In the Matter of)
)
Application by ViaSat, Inc.)
To Operate Earth Station)
In Duluth, Georgia)
in the 2085.0 – 2086.5 MHz band)

**REPLY OF GEORGIA TELEVISION COMPANY AND MEREDITH CORPORATION
TO OPPOSITION OF VIASAT, INC.**

ENGINEERING STATEMENT
IN SUPPORT OF REPLY
GEORGIA TELEVISION COMPANY AND
MEREDITH CORPORATION
ATLANTA, GEORGIA

Figure 1

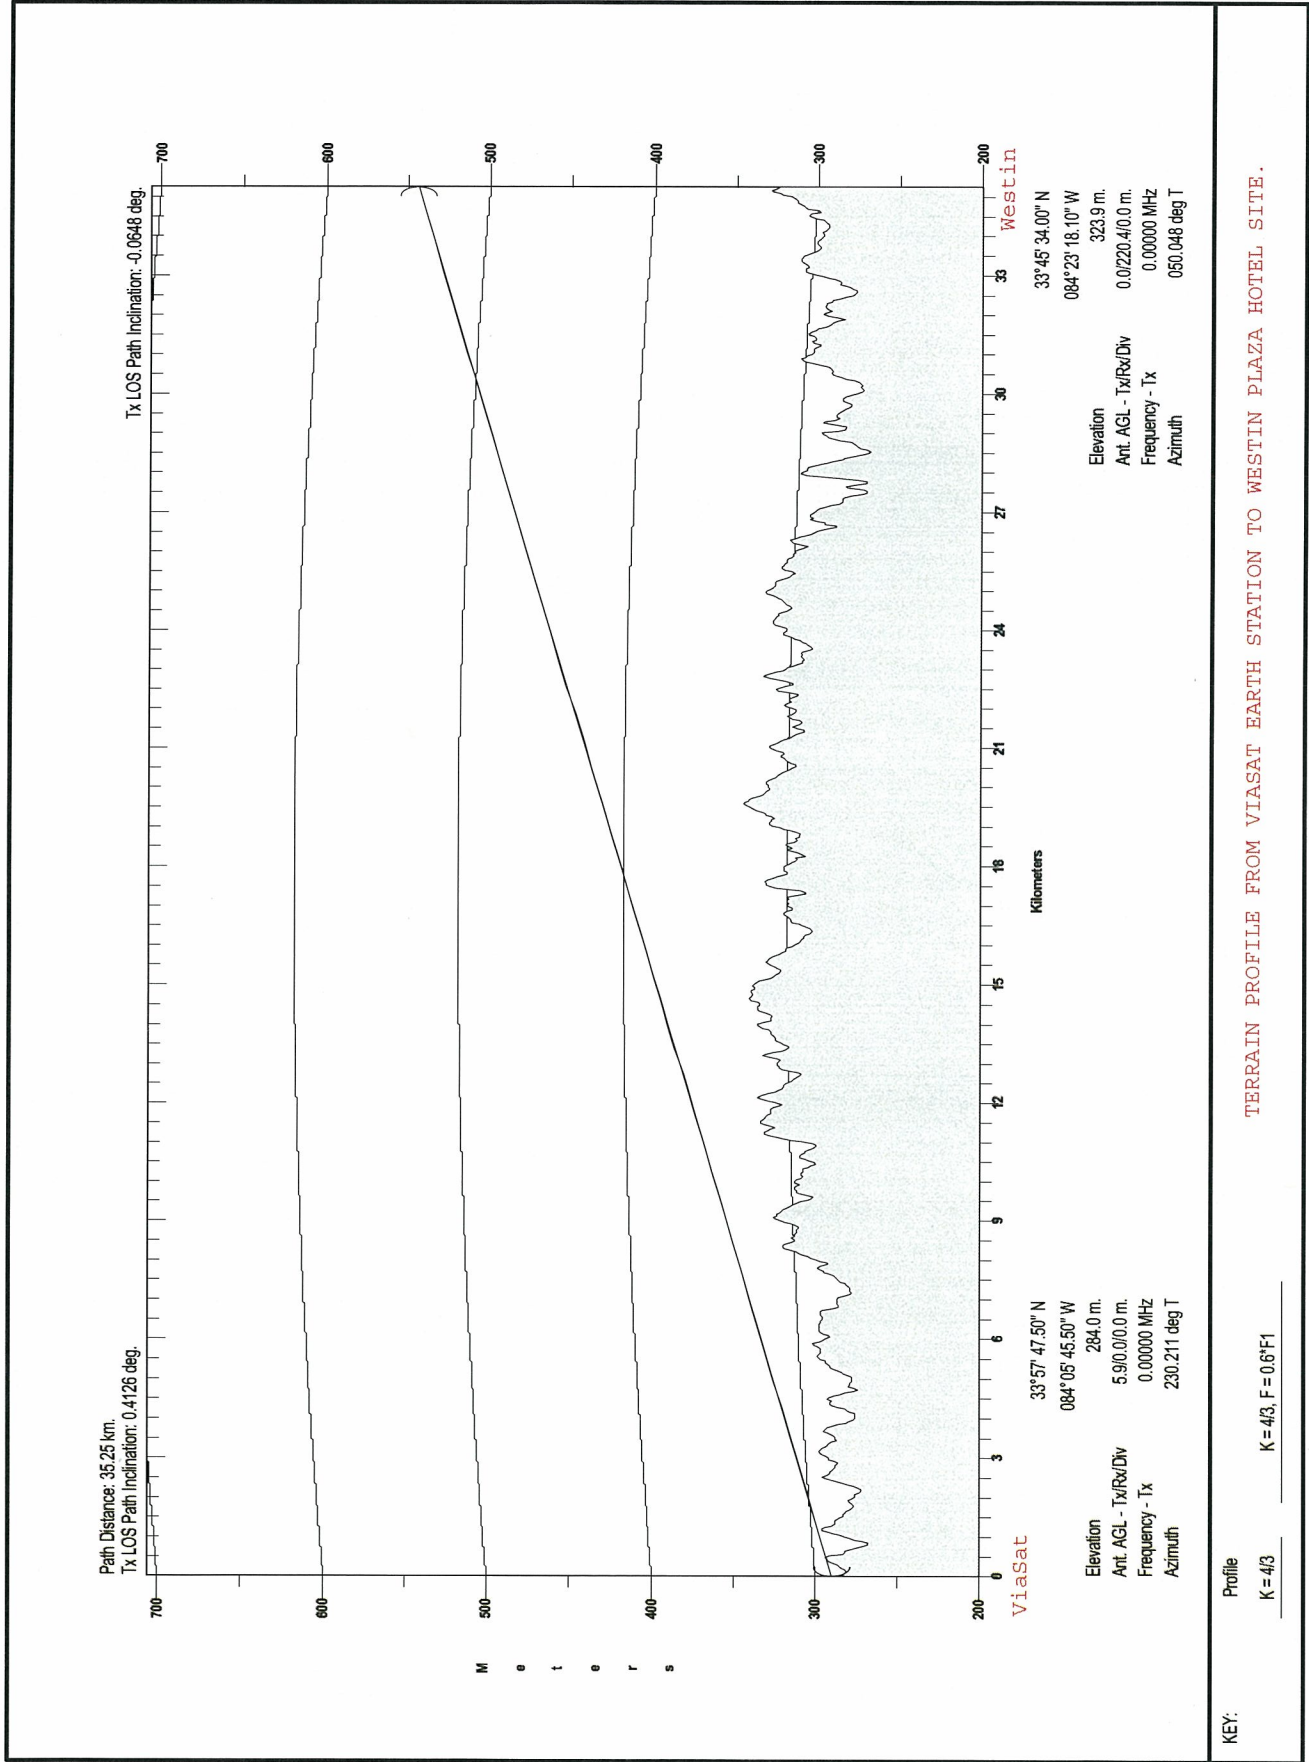
The first step in evaluating the interference from the ViaSat, Inc. earth station is a study of the terrain from the transmitting antenna location to each of the victim ENG receive locations. Terrain profiles from the ViaSat, Inc. earth station location to each of the ENG receive locations were prepared using the high resolution U.S.G.S. 1-second terrain database. These profiles are included herein as Figures 1 through 5.

Inspection of the terrain profiles indicates that there is a line-of-sight path from the ViaSat, Inc. earth station antenna to the Richland receiving antenna of the ENG system. This means that for this location free-space propagation losses should be considered for the evaluation of interference. Diffraction losses due to terrain obstructions would not be considered.

Figure 3

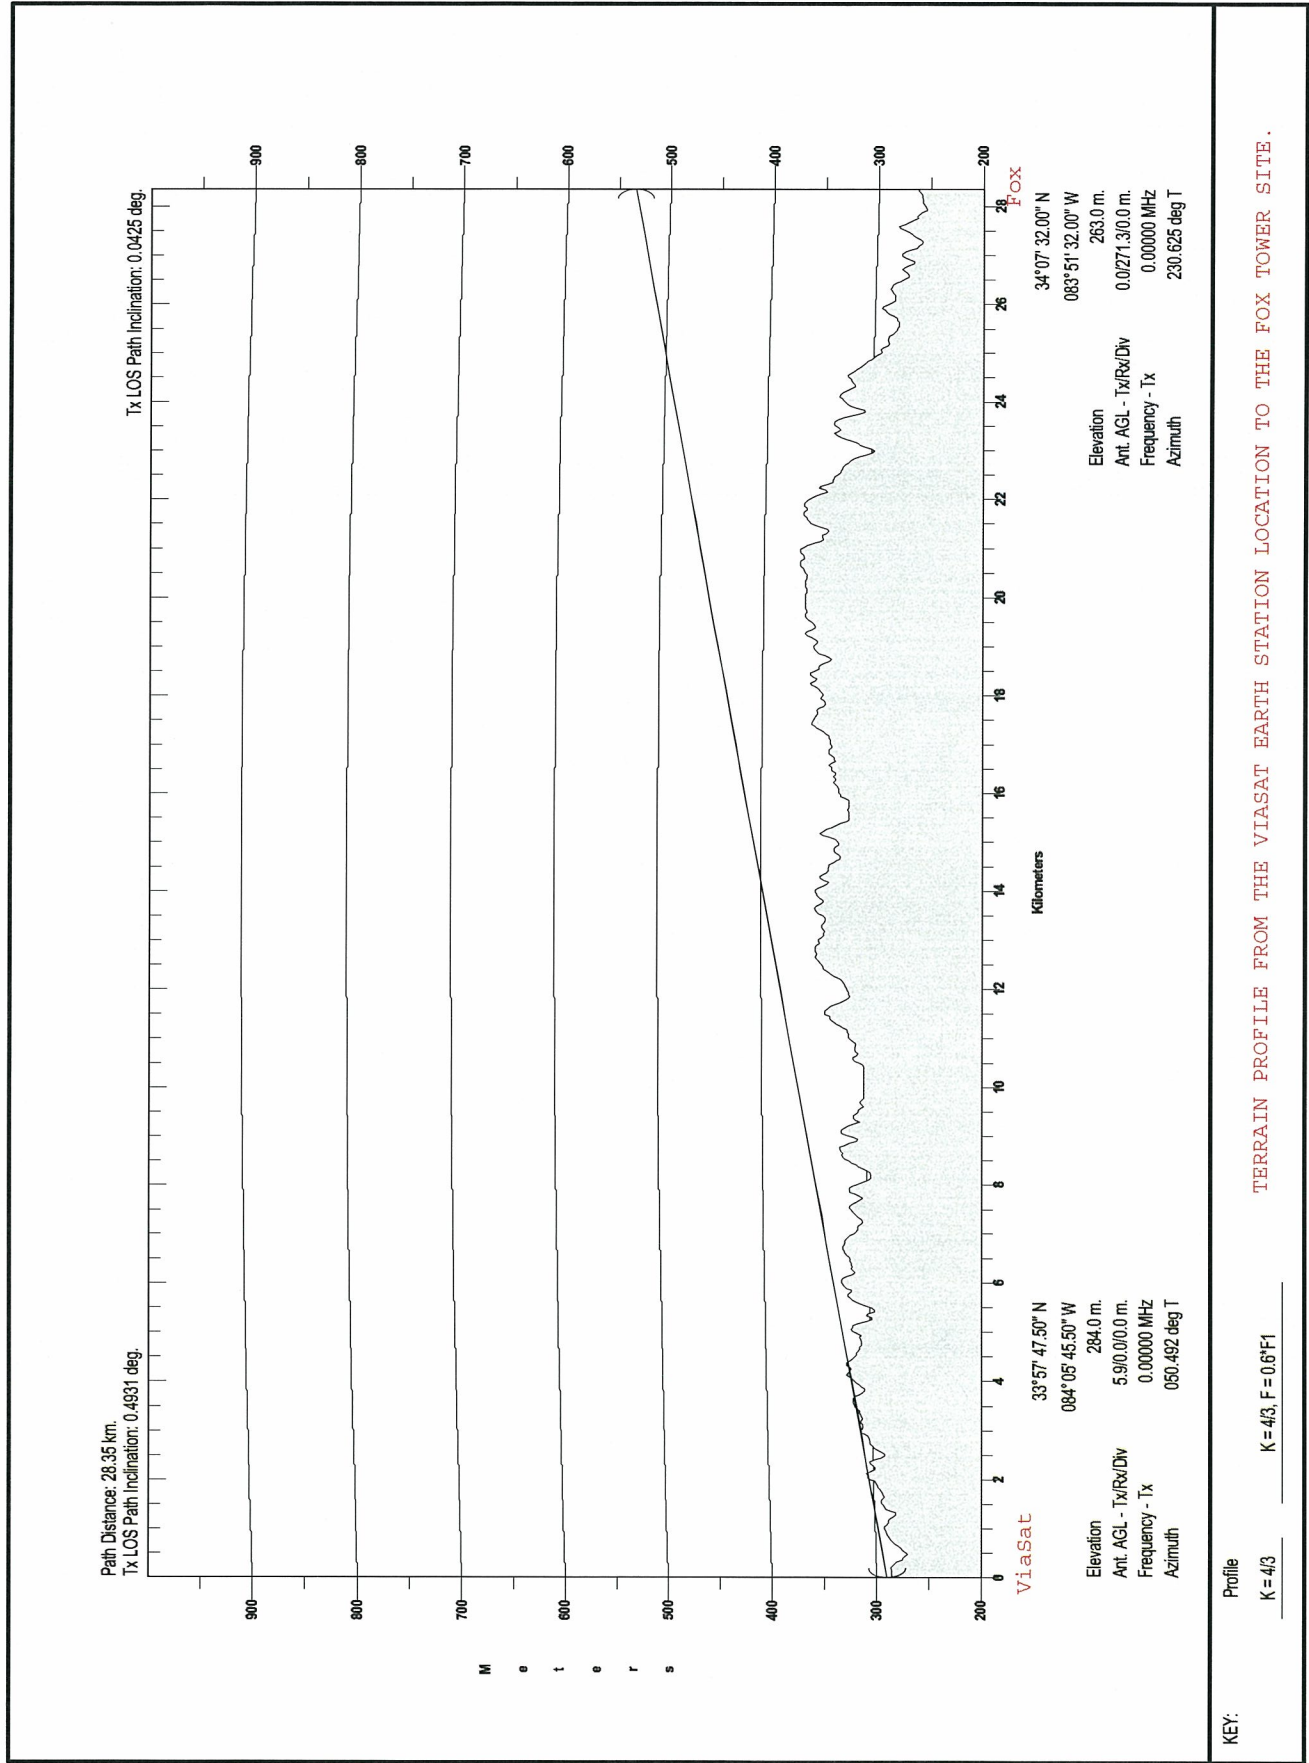
** It is noted that the geographic coordinates of the Fox tower location shown in the Technical Analysis included with the ViaSat, Inc. Opposition are in error. The latitude for the Fox tower site shown therein is 33-07-32. However, the correct latitude is 34-07-32. While this completely changes the orientation and distance from the earth station site, using the correct coordinate data to the Fox tower site still shows a terrain obstruction from the earth station. See Figure 3 herein.

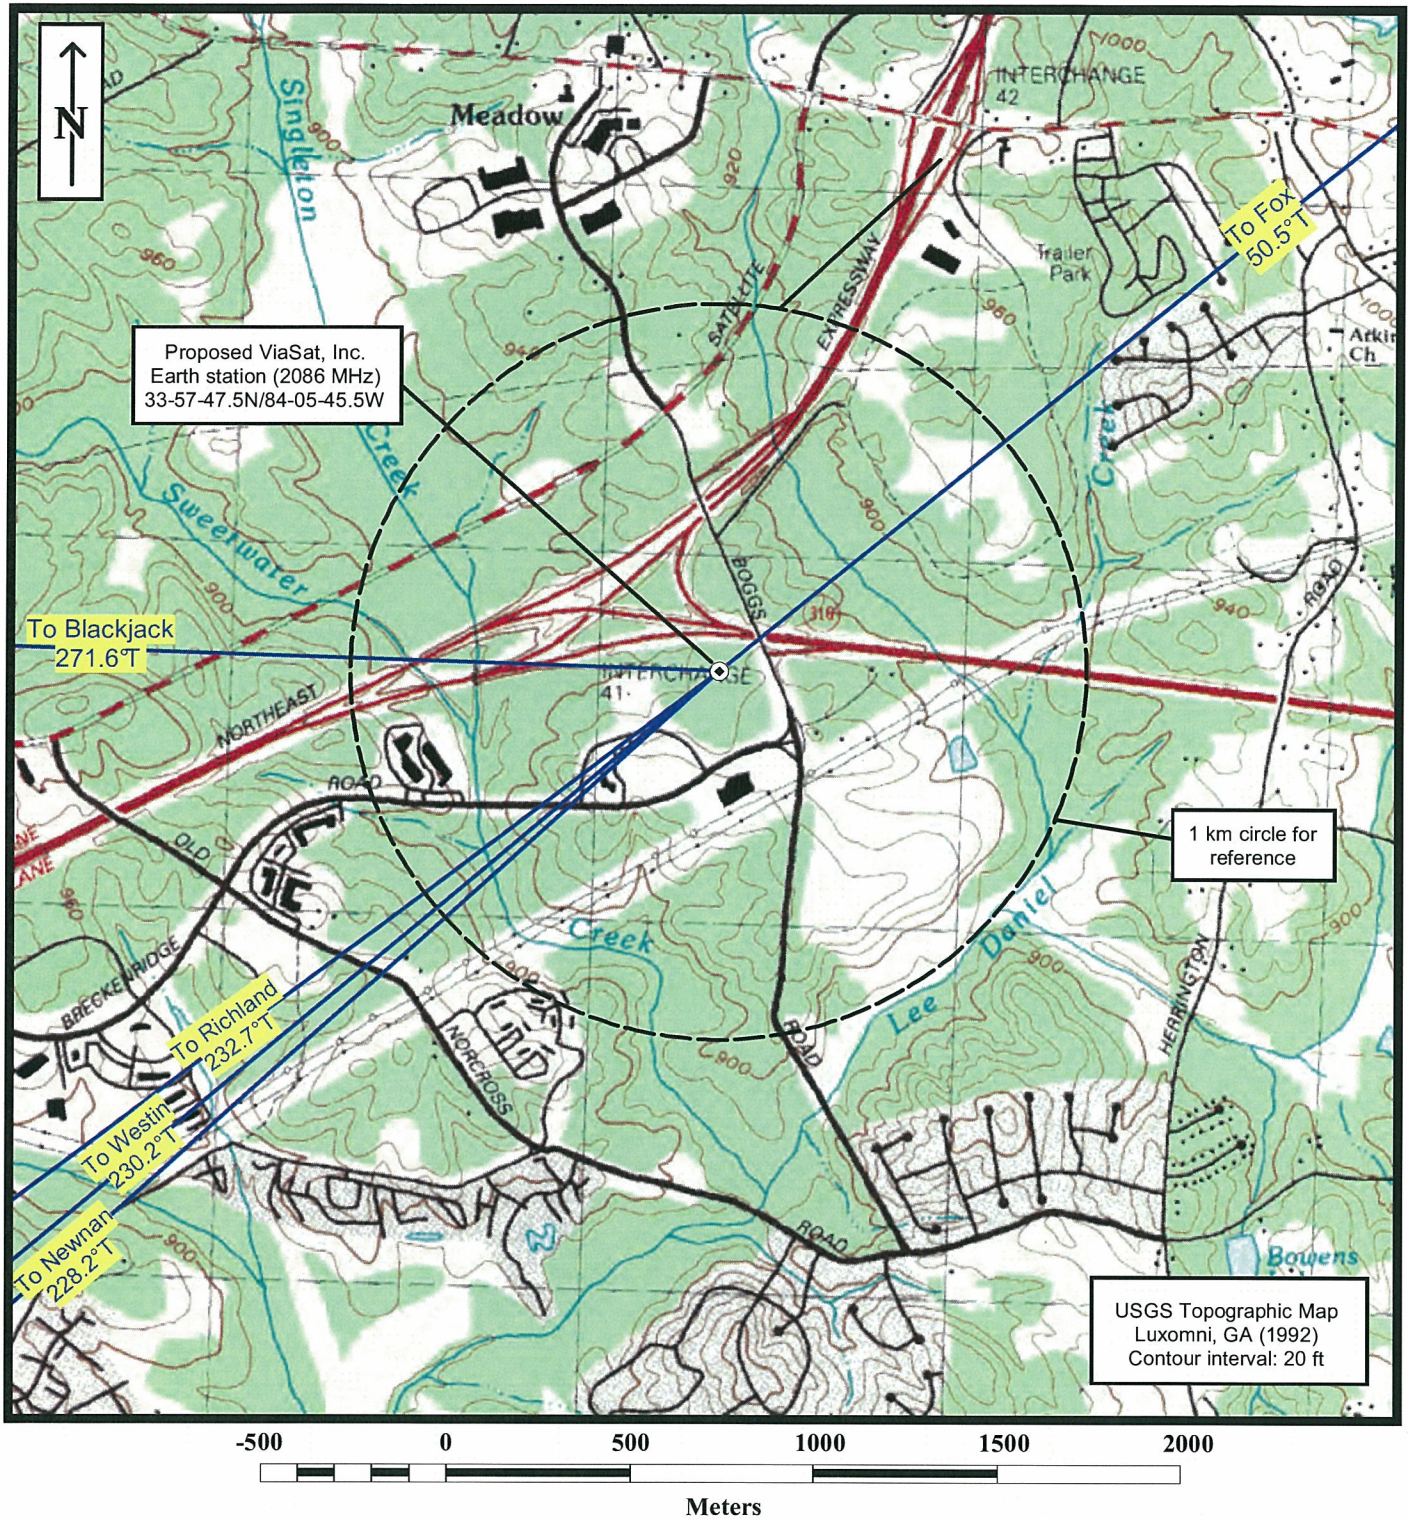
A topographic map showing the ViaSat, Inc. earth station transmitter site location and the radial directions to each of the ENG receive antennas was prepared by

the undersigned and is shown at Figure 6 herein. The topographic map data confirms the close-in terrain profile results shown in Figures 1 through 5. In addition, the topographic map clearly shows the absence of any terrain elevations that would cause a 3.7-meter terrain obstruction from the earth station to any of the ENG receive antennas.
